To: Kristopher Byrd, Well Construction Section Manager
From: Tommy Laird, Well Construction Program Coordinator
Subject: Re-Review of Water Right Application LL-1919
Date: December 12, 2023

Application # LL- 1919

TO: Water Rights Section Date May 4, 2023
 FROM: Groundwater Section Dennis Orłowski
 Reviewer's Name
 SUBJECT: Application LL- 1919 Supersedes review of _____
 Date of Review(s)

D1. Well #: _____ Logid: _____

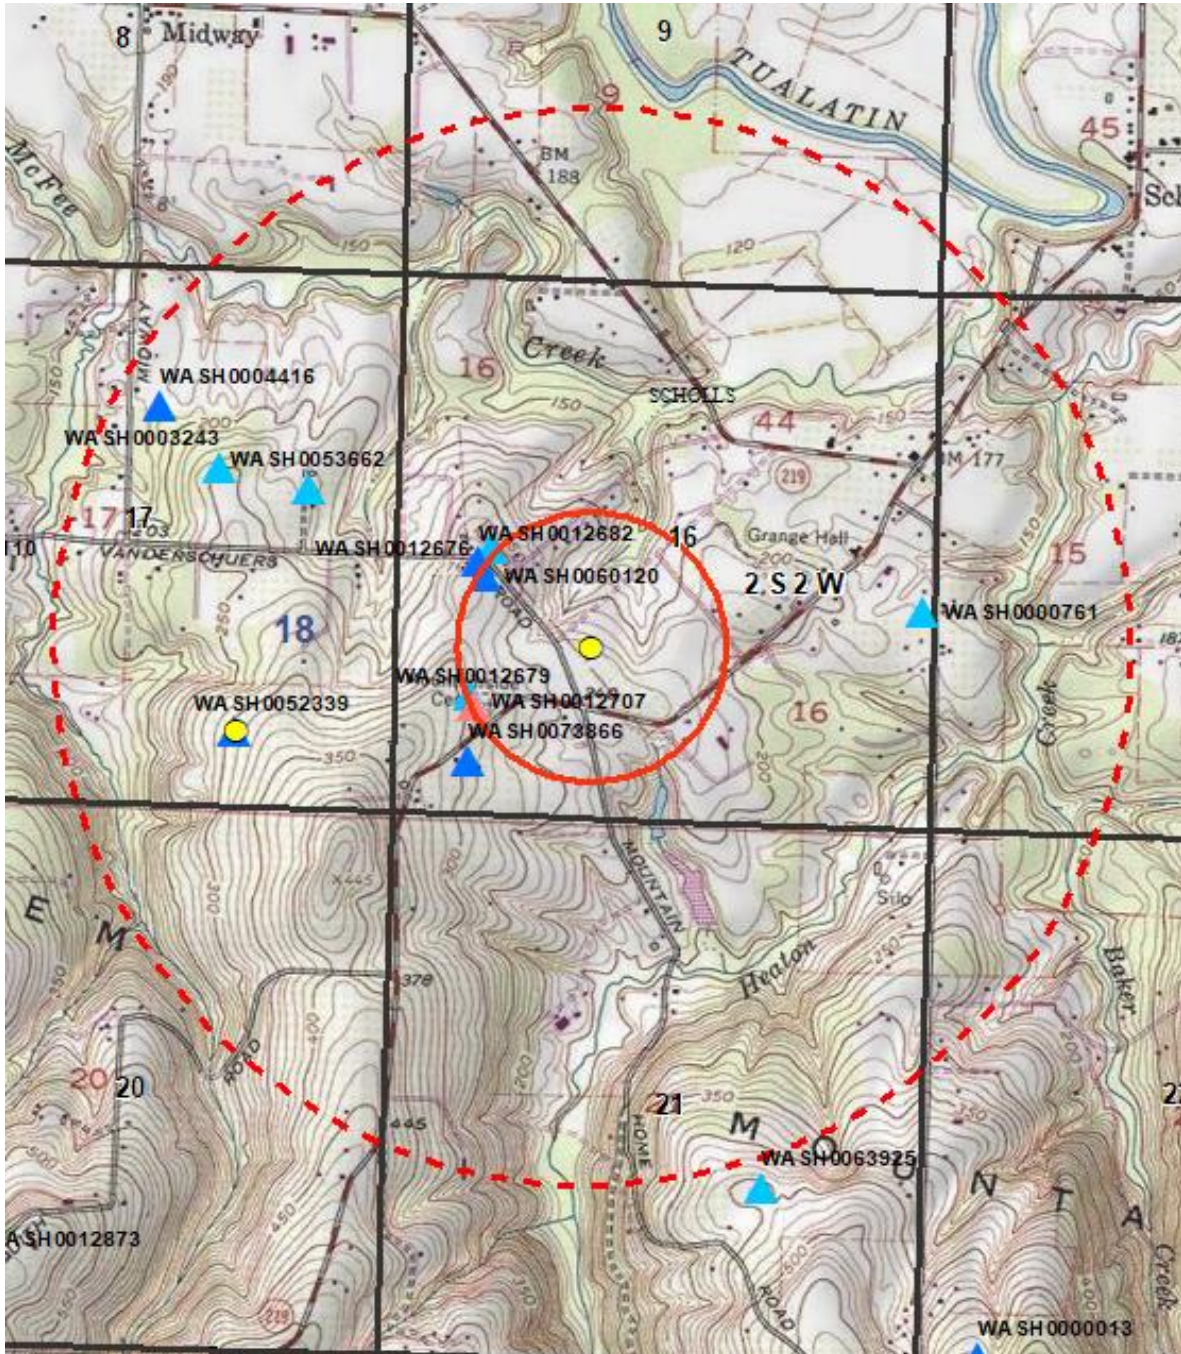
D2. **THE WELL does not appear to meet current well construction standards based upon:**

- a. review of the well log;
- b. field inspection by _____;
- c. report of CWRE _____;
- d. other: (specify) _____

D3. **THE WELL construction deficiency or other comment is described as follows:** _____

D4. **Route to the Well Construction and Compliance Section for a review of existing well construction.**
